DECISION UNDER THE AIRPORTS (PROTECTION OF AIRSPACE) REGULATIONS 1996:

Proposed Activity: Building Construction: Multi-storey building

Location: Crown Sydney Resort, Barangaroo NSW

Proponent: Crown Resorts Ltd

Attachments A1-A2 show the location and height of the building which will intrude into prescribed airspace at the site.

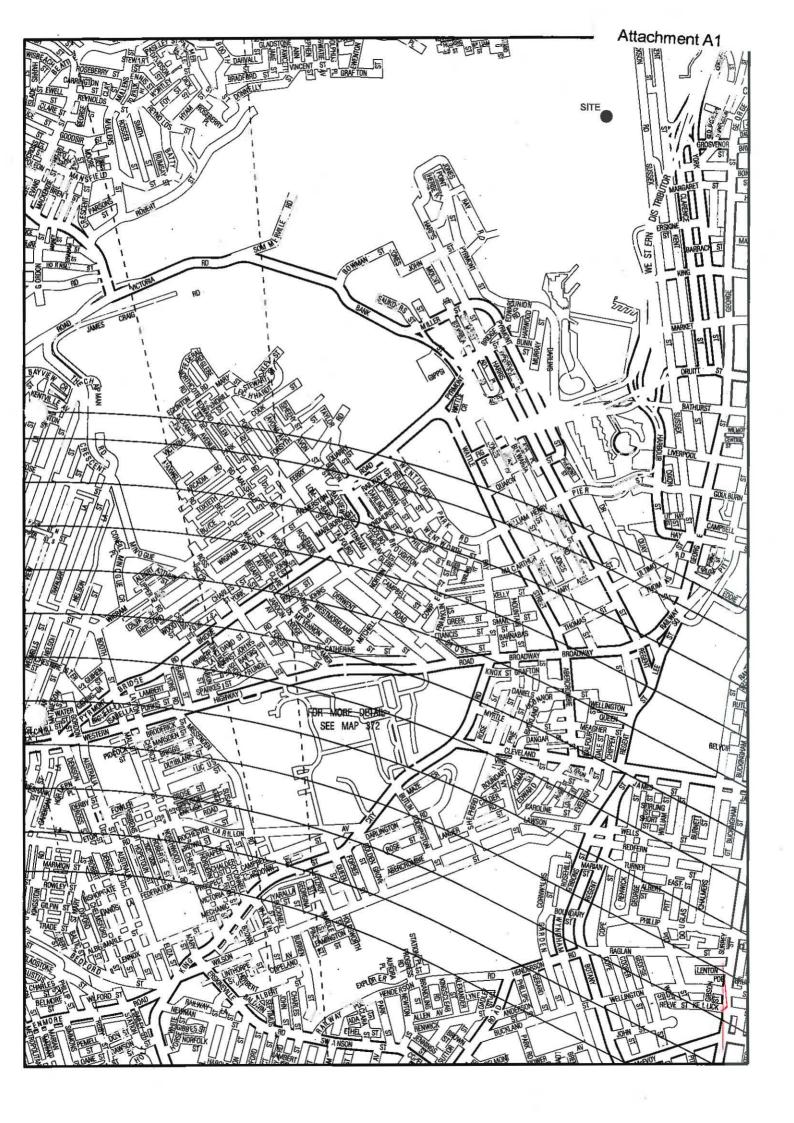
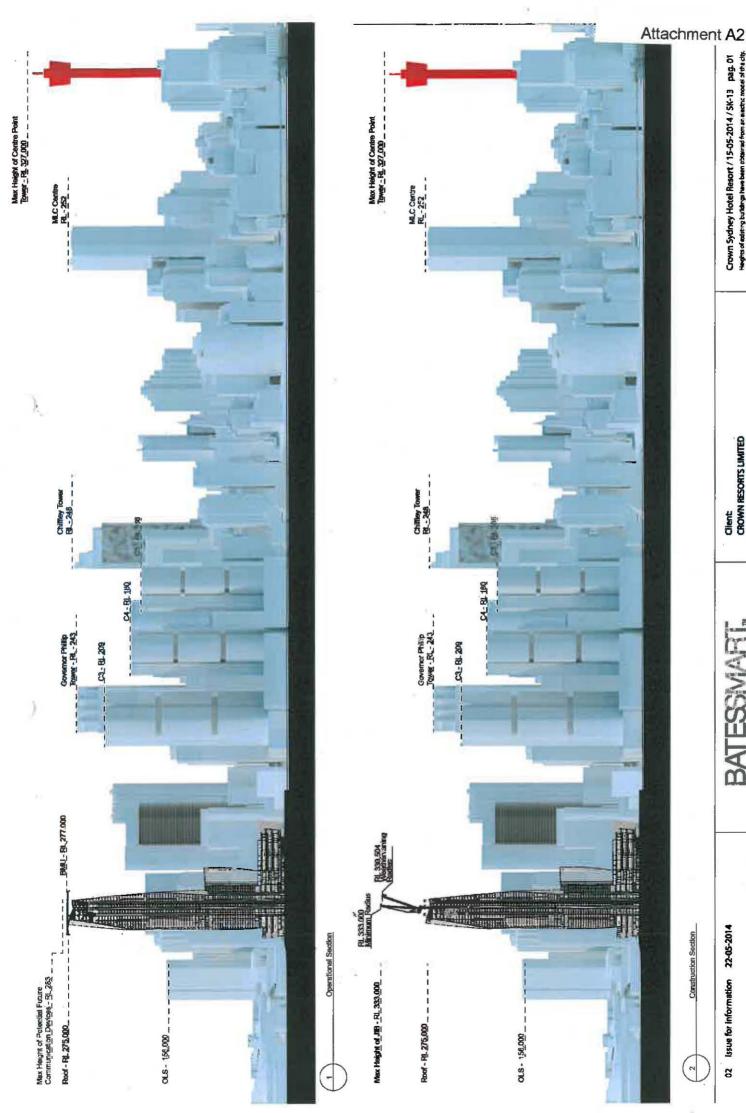
The Outer Horizontal Surface of the OLS above this site is at a height of 156 metres Australian Height Datum (AHD) and hence prescribed airspace above the site commences at 156 metres. At a maximum height of 283 metres AHD, the building will penetrate the OLS by 127 metres.

- 1. The building must **not exceed** a maximum height of **283 metres AHD**, inclusive of all lift over-runs, vents, chimneys, aerials, antennas, lightning rods, any roof top garden plantings, exhaust flues etc.

- 2. The building **must** be obstacle lit by medium intensity flashing red lighting during the hours of darkness at the highest point of the building. Obstacle lights are to be arranged so as to at least indicate the points or edges of the building to ensure the building can be observed in a 360° radius as per subsection 9.4.3 of the Manual of Standards Part 139-Aerodromes (MOS Part 139). Characteristics for medium intensity lights are stated in subsection 9.4.7 of MOS Part 139.

- 3. The building **must** be obstacle lit by low intensity steady red lighting during the hours of darkness on the southern and north western corners of the building. The low intensity steady red lighting is to indicate the height of the building. These lights are to be placed as equally as possible, between the medium intensity flashing red lighting on the top of the building and 156m AHD. The spacing between the lights is not to exceed 45m. Characteristics for low intensity lights are stated in subsection 9.4.6 of MOS Part 139.
